COMMONWEALTH OF KENTUCKY
BEFORE THE PUBLIC SERVICE COMMISSION

APPLICATION OF KENTUCKY UTILITIES)	
COMPANY FOR A CERTIFICATE OF PUBLIC)	CASE NO: 2017-00483
CONVENIENCE AND NECESSITY AND)	
APPROVAL OF AMENDMENT TO ITS 2016)	
COMPLIANCE PLAN FOR RECOVERY BY)	
ENVIRONMENTAL SURCHARGE)

**RESPONSE TO TECHNICAL NOTICE OF
DEFICIENCY (NOD) No.1
SITEWIDE GROUNDWATER
REMEDIAL ACTION PLAN**

**Subject: Response to Technical Notice of Deficiency (NOD) No.1
Sitewide Groundwater Remedial Action Plan
Kentucky Utilities (KU) - E.W. Brown Generating Station
Burgin, Mercer County, Kentucky
Agency Interest No. 3148
Application ID No. ARM20150001
AMEC Project No. 567530023**

E.W. Brown Main Ash Pond Dam Stability

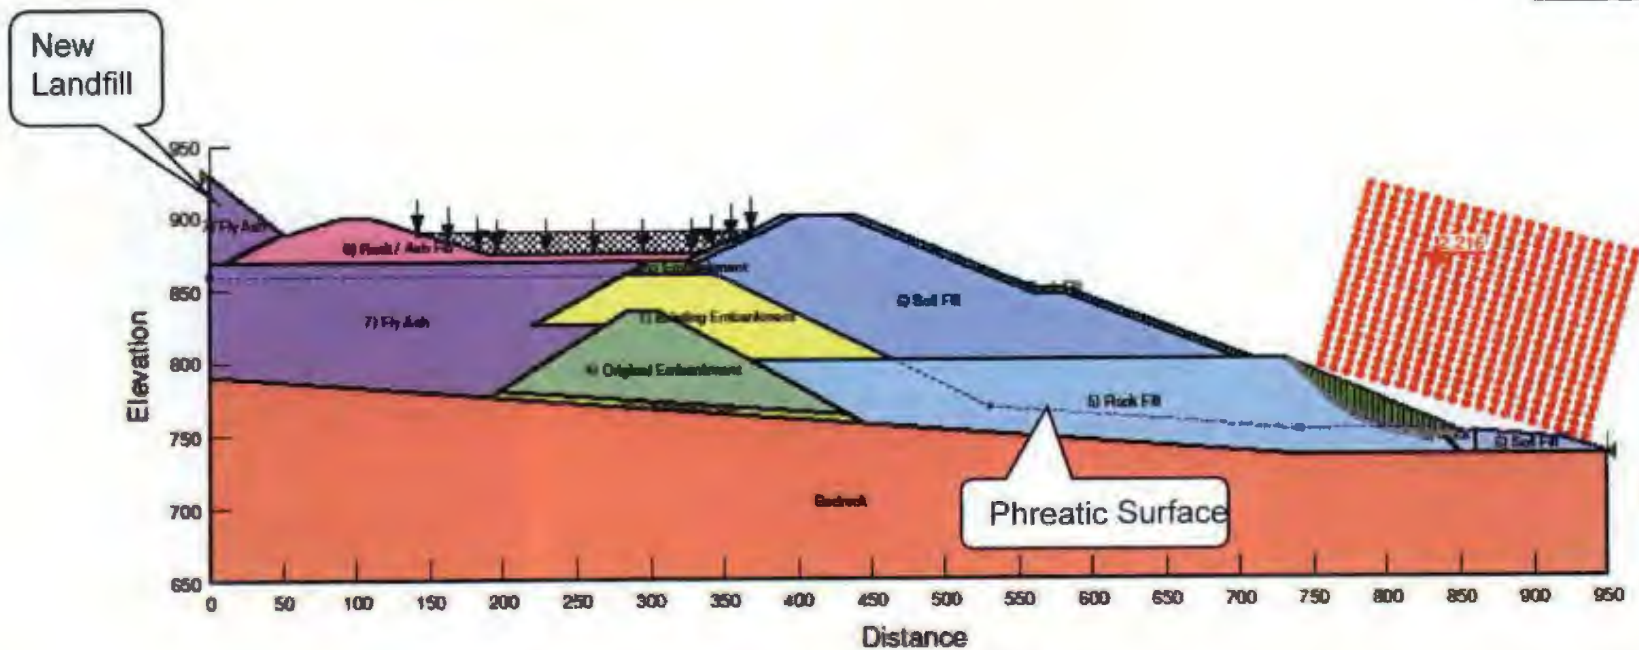
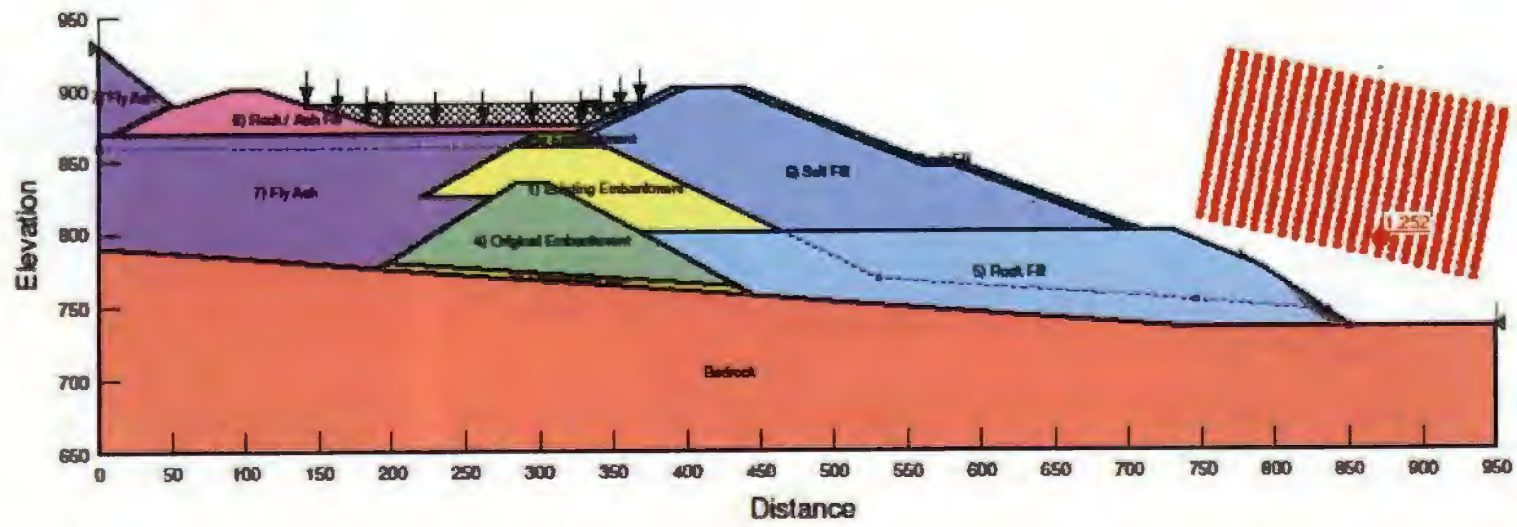
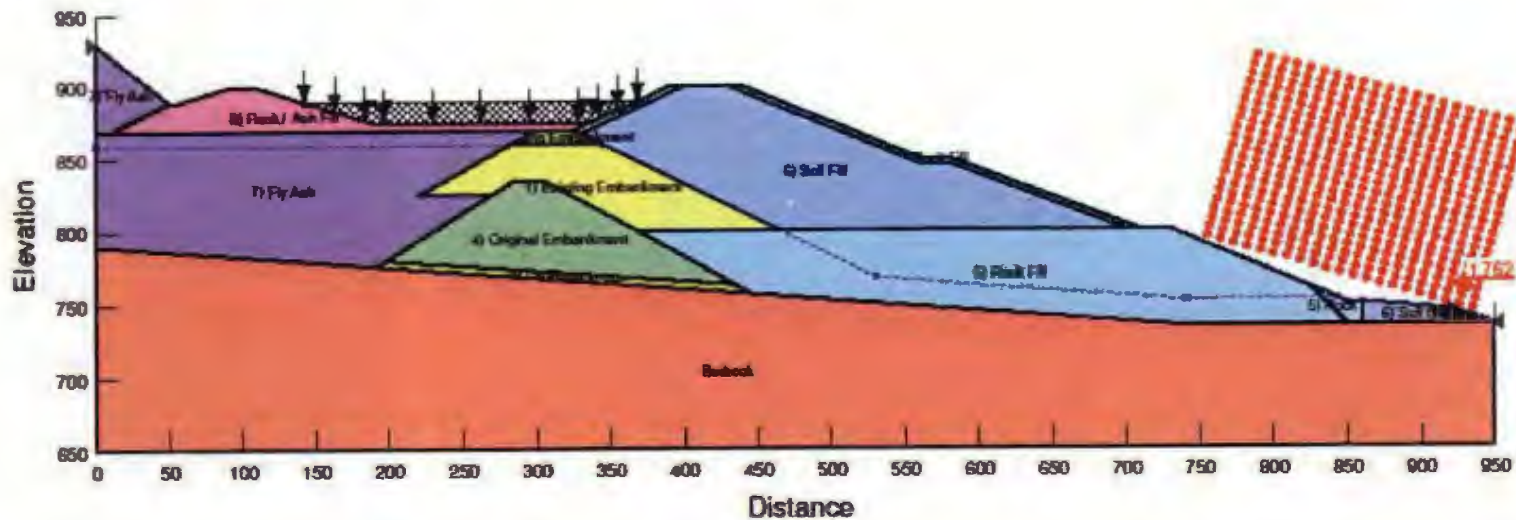
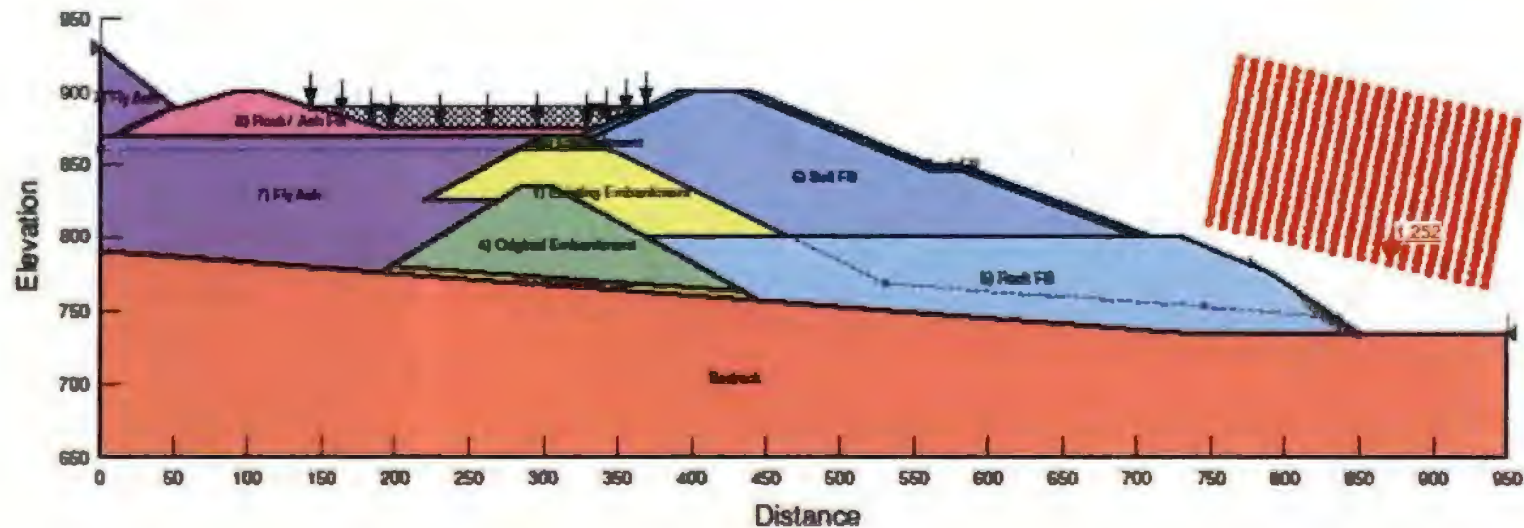
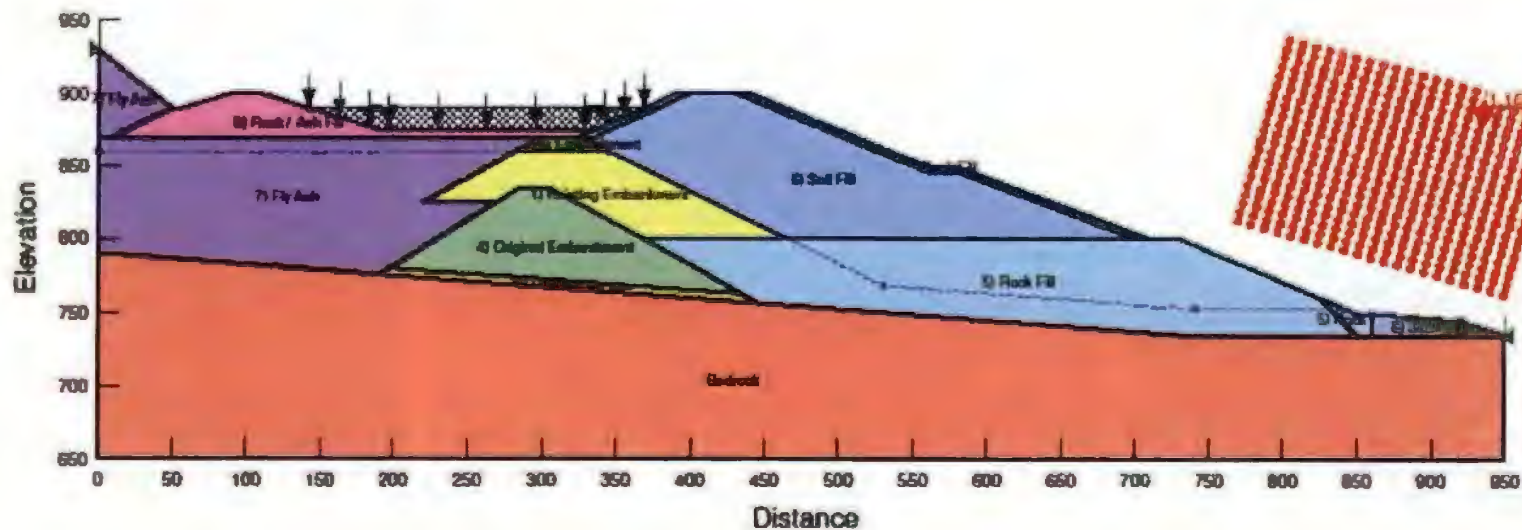
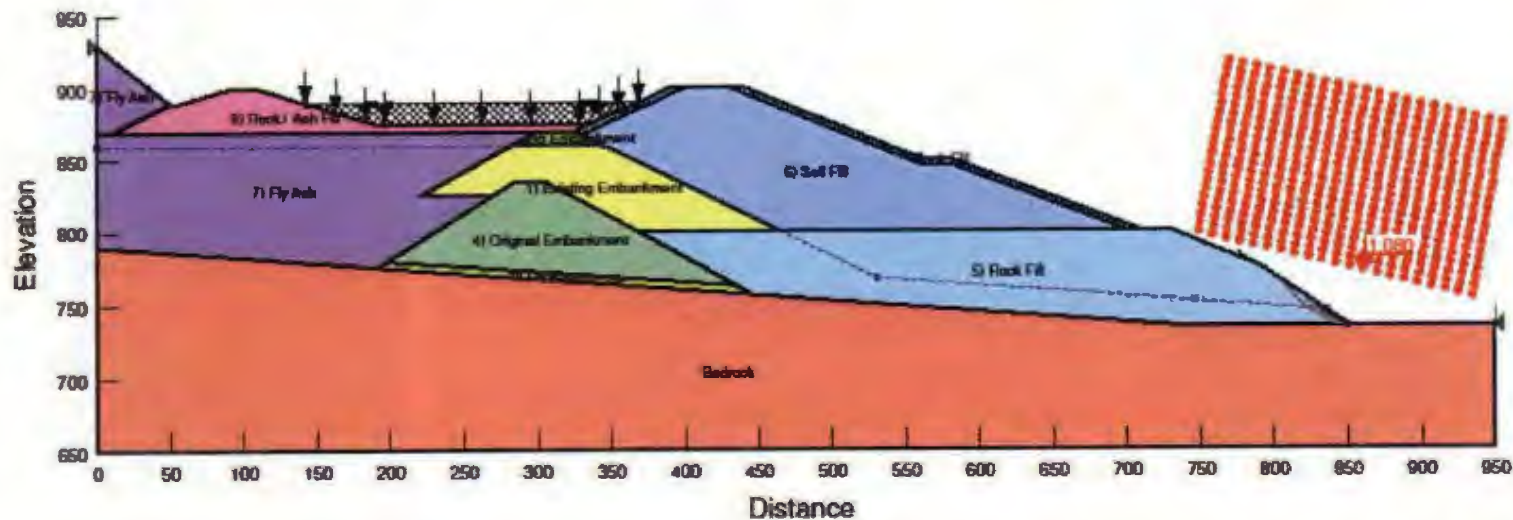
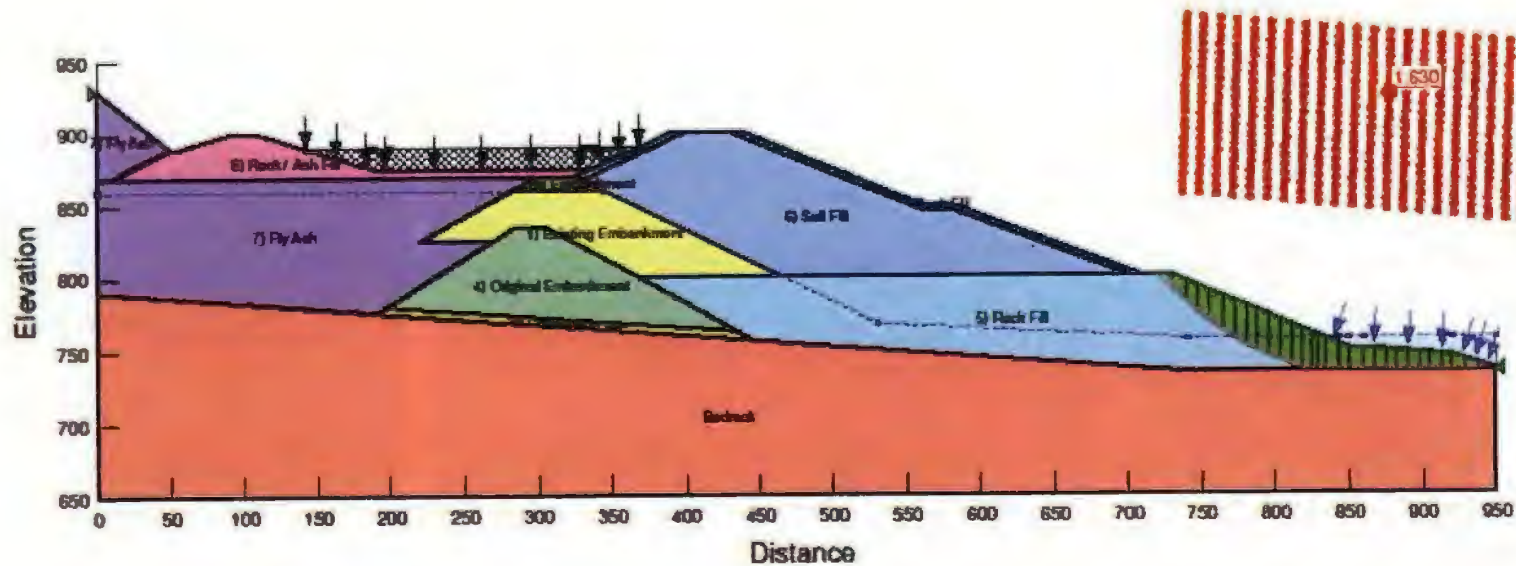
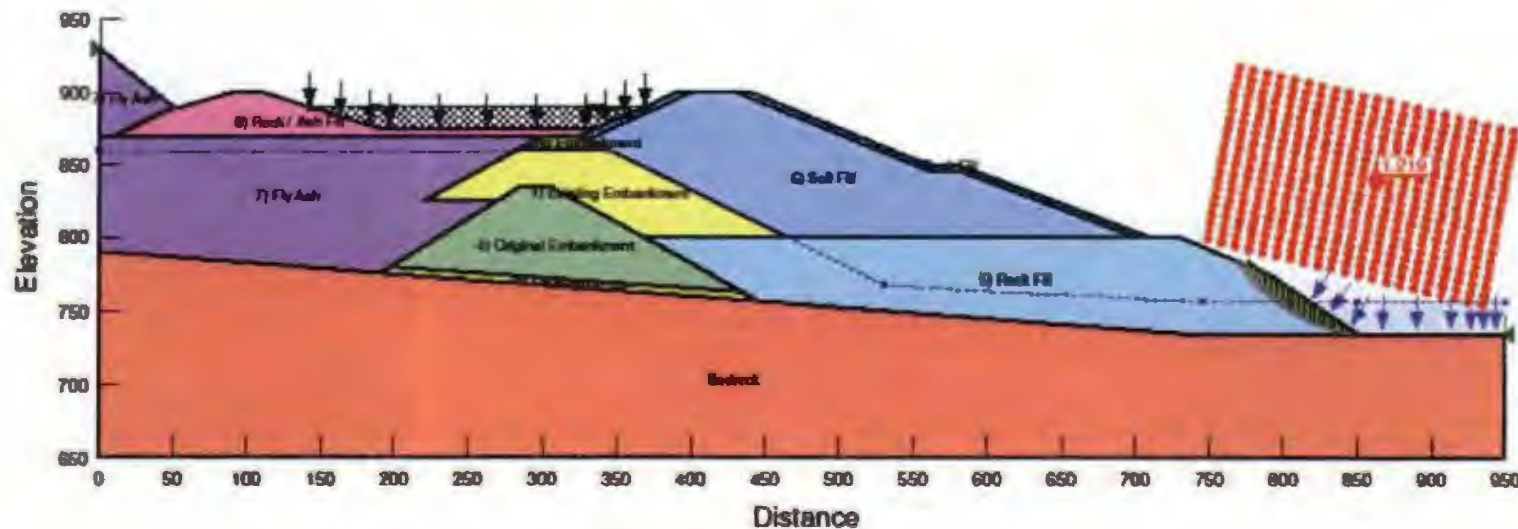
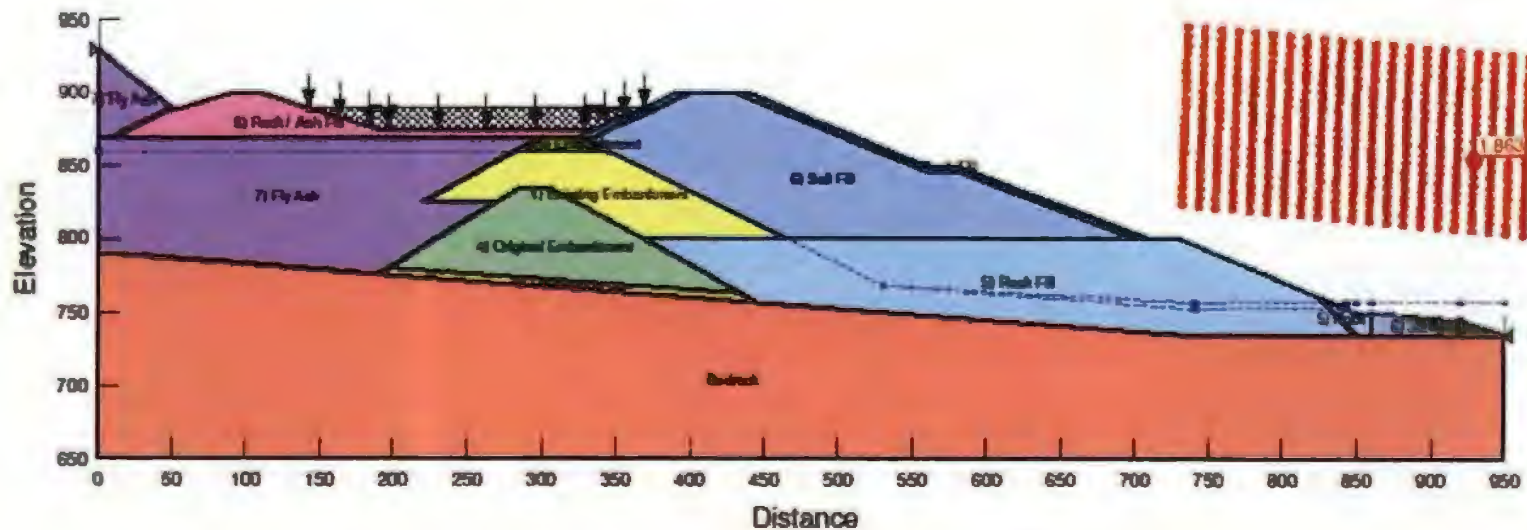
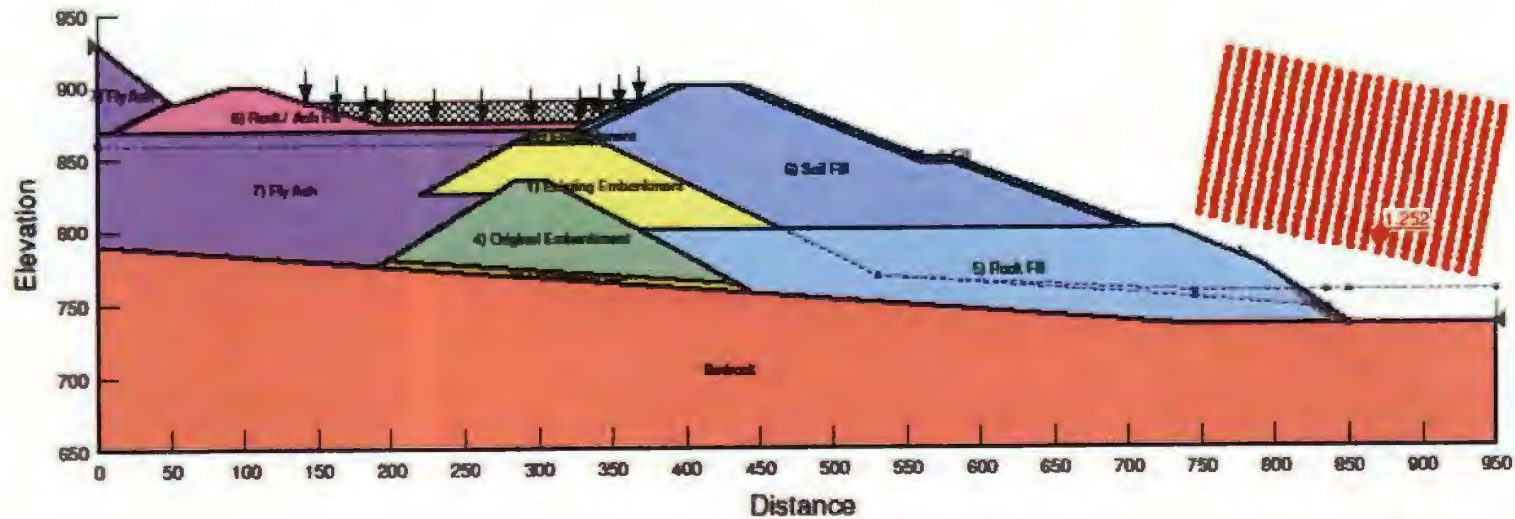
5. *Provide a slope stability analysis for the existing ash pond dam during and following construction of the cut-off wall.*
